REV2 REFERENCE / REDESIGN IN PROGRESS

22 September 2026: the current print order is N1 nose only.

The following pages retain the old Rev2 design for reference. They are not the current full-aircraft manufacturing instructions. Their original page numbers remain unchanged; this notice is an additional page.

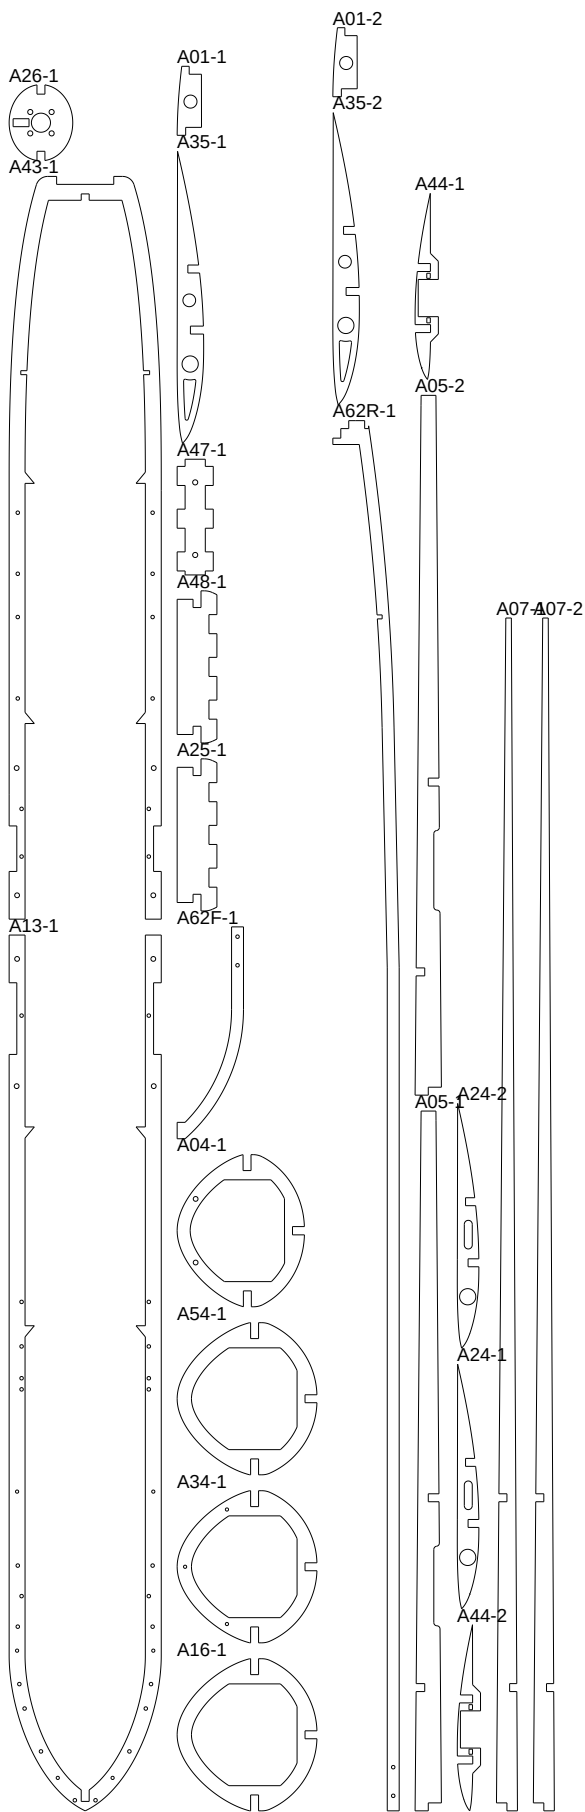
Superseded for the new design

Landing gear and steering system; the old 42-piece print order; A59 cover screw holes, columns, spacers and shaped washers; the large nose pitot-access notch. Do not fabricate these from the old instructions.

N1 restores the original upper nose shell. It uses a proposed simple ledge/tape attachment and a probe passage drilled to actual hardware during assembly. It retains the original rear mating envelope.

Use Manufacturing/Nose_Print_N1/A59_Nose_N1_mm.stl and Nose_N1_Print_Guide.pdf. Quantity one, millimetres, 100%.
